CARVIN
R600, R1000
System Master

DRAWN BY: GEORGE DREYER DATE: 10JUNE97
 APPROVED: DATE:
 PCB NO: 30-40600 REV: H
 ASBY: 80-40626 REV: J
 NO: 80-41000 REV: K
 REVISED BY: C. MICELEN DATE: 15SEP98

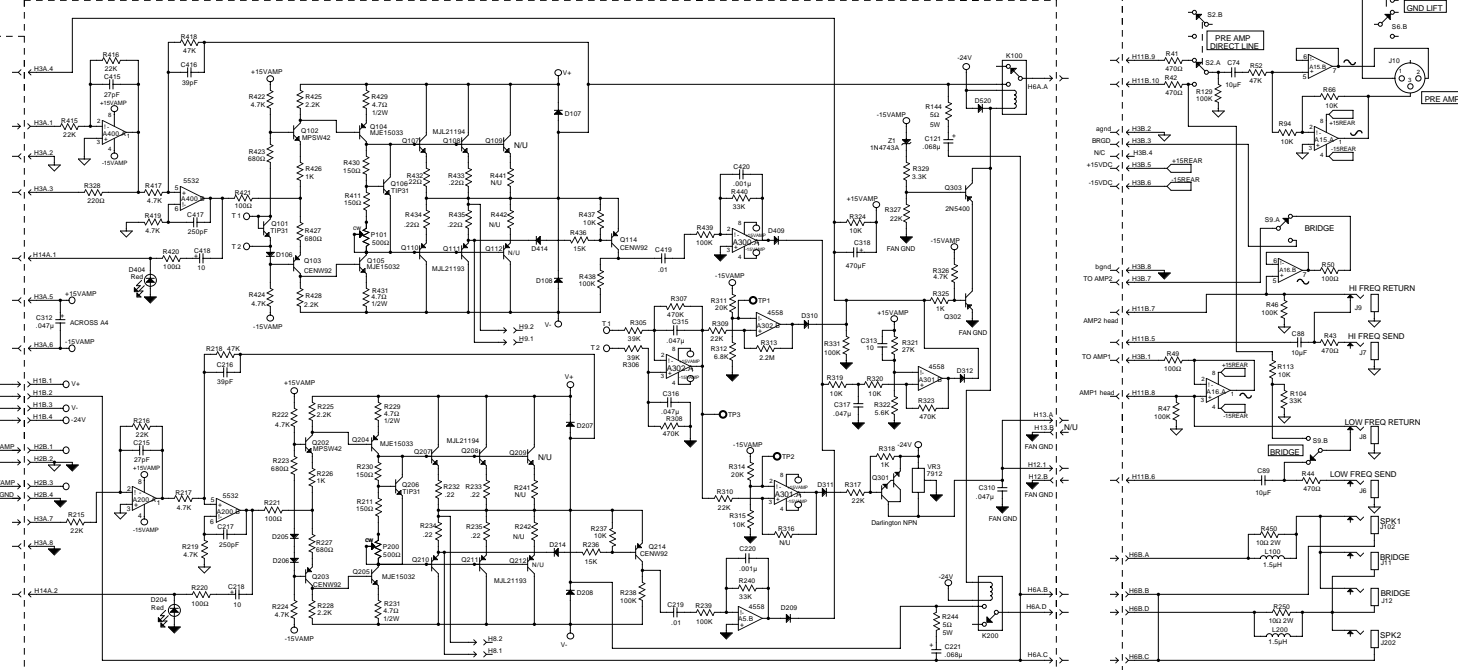
- Changes from Assembly Rev (H3).
 1. Revised jacks to front panel.
 2. Revised header numbering.
 3. Revised PCB to Rev (G).
- Changes from Assembly Rev (H4).
 1. Moved Clip LEADS to Front PCB D103, D203.
 2. Revised headers H3 & H4.
 3. Revised PCB to Rev (H).
- Changes from Assembly 80-41000 Rev (I).
 1. R519 from 100Ω to 36Ω.
- Changes from Assembly 80-41000 and 80-40626 Rev (J&K).
 1. C28 from .022μ to .033μ.

- CHANGES FOR R1000 ASSEMBLY: 80-41000
- Add Q109, Q209 (Type: MLL 2119A).
 - Add Q112, Q212 (Type: MLL 2119S).
 - Add R441, R442, R241, R242 (0.22Ω).
 - Change C501, C502 to 100kM² @ 80V.
 - Change R217, R417 From 4.7K to 3.3K.
